HISTORIC AND DESIGN REVIEW COMMISSION

March 17, 2021

HDRC CASE NO: 2021-081
ADDRESS: 415 LABOR ST
LEGAL DESCRIPTION: NCB 926 BLK 7 LOT W IRR 90.7 FT OF E IRR 190.85 FT OF 4
ZONING: RM-4, H
CITY COUNCIL DIST.: 1
DISTRICT: Lavaca Historic District
APPLICANT: Lauri Azzaro/Real Life Ministries
OWNER: Sean Azzaro/REAL LIFE MINISTRIES
TYPE OF WORK: Window replacement
APPLICATION RECEIVED: February 10, 2021
60-DAY REVIEW: Not Applicable Due to City Council Emergency Orders
CASE MANAGER: Rachel Rettaliata

The applicant is requesting a Certificate of Appropriateness for approval to replace 8 existing aluminum windows with new vinyl windows.

Window Replacement Schedule

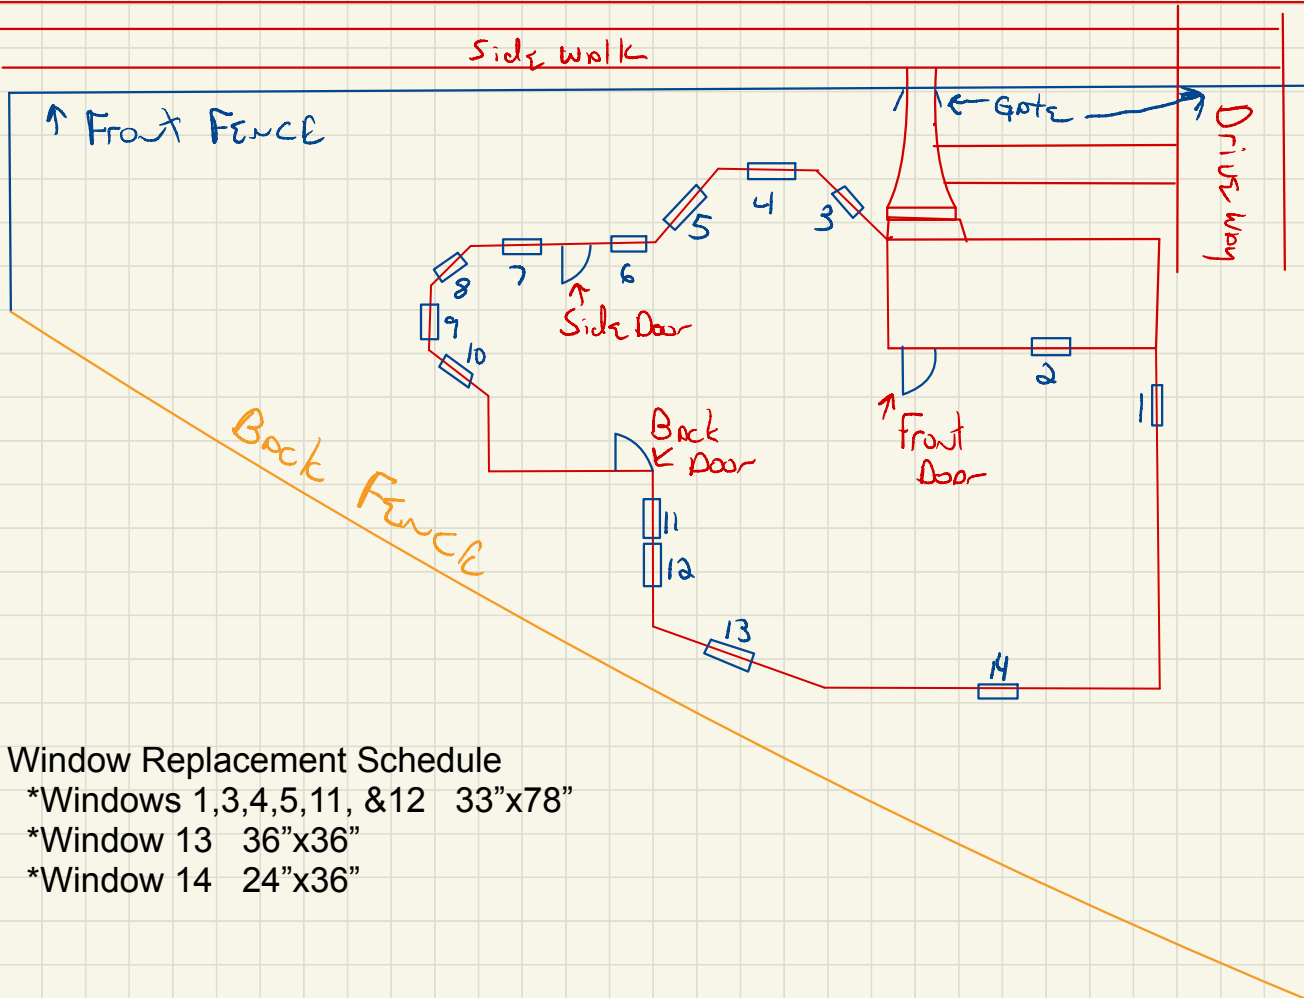
- c. WINDOW REPLACEMENT – The applicant has proposed to replace 8 existing aluminum windows with vinyl replacement windows. The existing wood windows on the structure are not included in the request for replacement and will be repaired. Guideline 6.B.vii for Exterior Maintenance and Alterations states that non-historic incompatible windows should be replaced with windows that are typical of the architectural style of the building. Staff finds the proposed vinyl replacement windows inappropriate.

- i. That the applicant installs fully wood windows or aluminum-clad wood windows that meet staff's standard window stipulations and submits updated specifications to staff for review and approval. The windows should feature an inset of two (2) inches within facades and should feature profiles that are found historically within the immediate vicinity. Meeting rails must be no taller than 1.25" and stiles no wider than 2.25". White manufacturer's color is not allowed, and color selection must be presented to staff. There should be a minimum of two inches in depth between the front face of the window trim and the front face of the top window sash. This must be accomplished by recessing the window sufficiently within the opening or with the installation of additional window trim to add thickness. Window trim must feature traditional dimensions and architecturally appropriate sill detail. Window track components must be painted to match the window trim or concealed by a wood window screen set within the opening.
